Enclosure 2

MFN 09-257

**DCD Markups for
RAI Number 16.2-186**

Figure 2.2.2-1. Control Rod Drive System

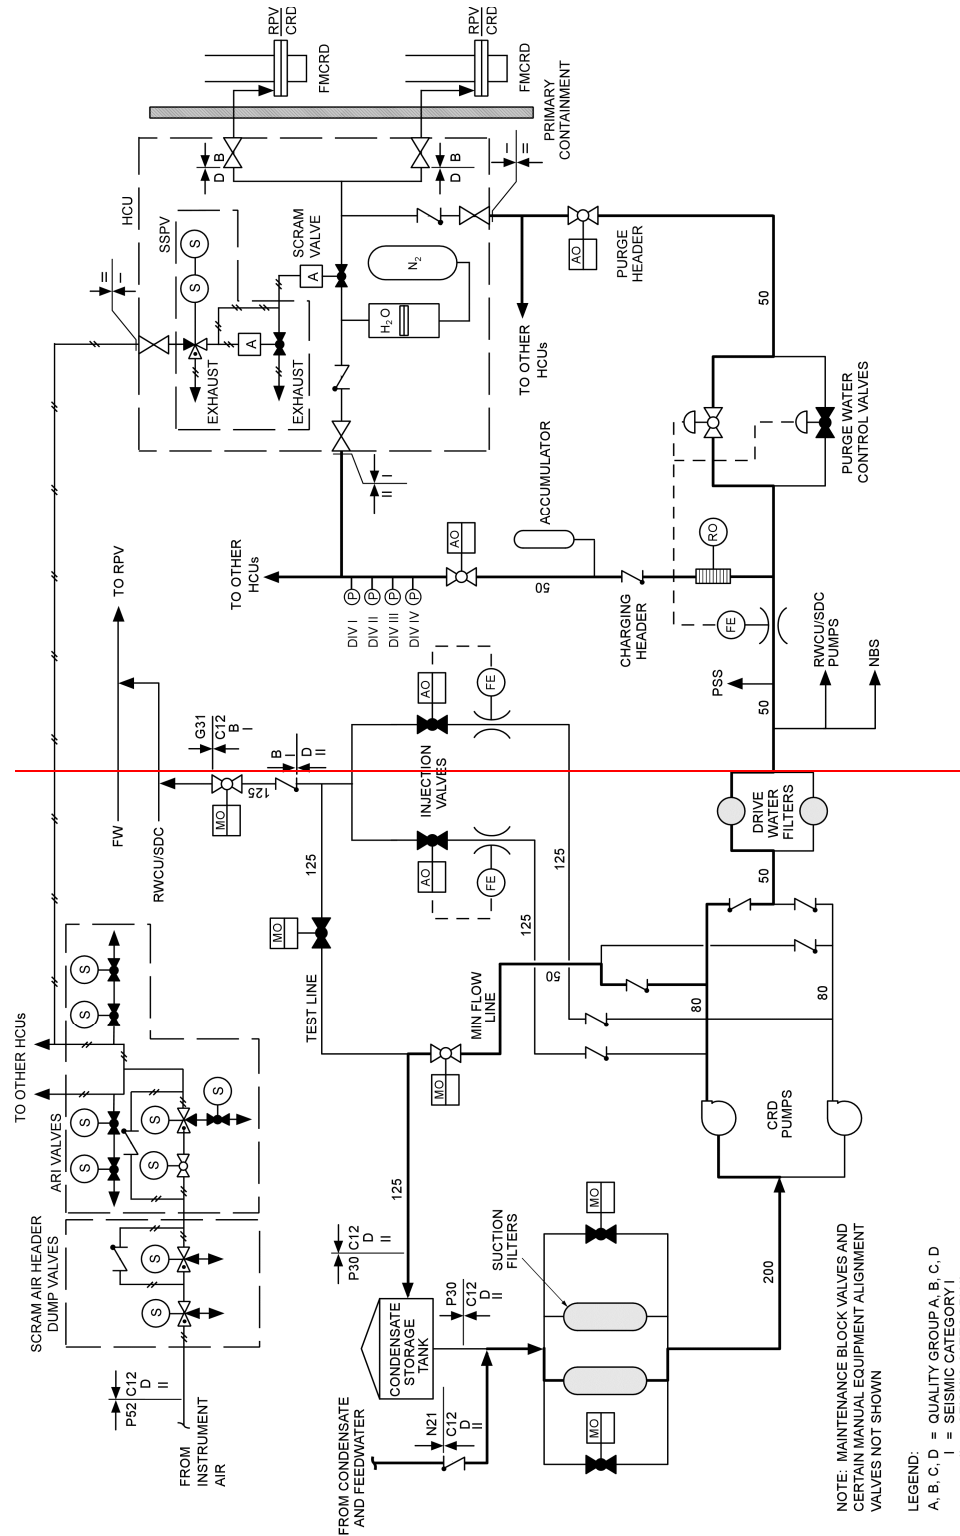
Equipment Name (Description)	Equipment Identifier See Figure 2.2.2-1	Control Q-DCIS/DPS See Note 1	Seismic Category I	Safety-Related	Safety-Related Display	Active Safety Function	Loss of Motive Power Position	Remotely Operated Valve
HCU scram solenoid pilot valves	SSPV	Yes	Yes	Yes	Associated scram valve position status	Energize to apply air to HCU scram valve	Vent HCU scram valve	By RPS system logic
FMCRD passive holding brakes	FMCRD	No	Yes	Yes	Yes	Release brake	Apply brake	-
HCU Scram accumulator charging water header pressure transmitters	Div 1-4	Yes	Yes	Yes	MCR alarm	-	-	-
FMCRD separation switches	FMCRD	Yes	Yes	Yes	MCR alarm	-	-	-
<u>High pressure makeup isolation valves</u>	<u>HP CRD Isolation valves</u>	<u>Yes</u>	<u>Yes</u>	<u>Yes</u>	<u>MCR valve position</u>	<u>Close</u>	<u>Close</u>	<u>Yes</u>
<u>High pressure makeup isolation bypass valves (not including valve operator)</u>	<u>HP CRD Isolation Bypass valves</u>	<u>Yes</u>	<u>Yes</u>	<u>Yes</u>	<u>MCR valve position</u>	<u>-</u>	<u>As-Is</u>	<u>Yes</u>
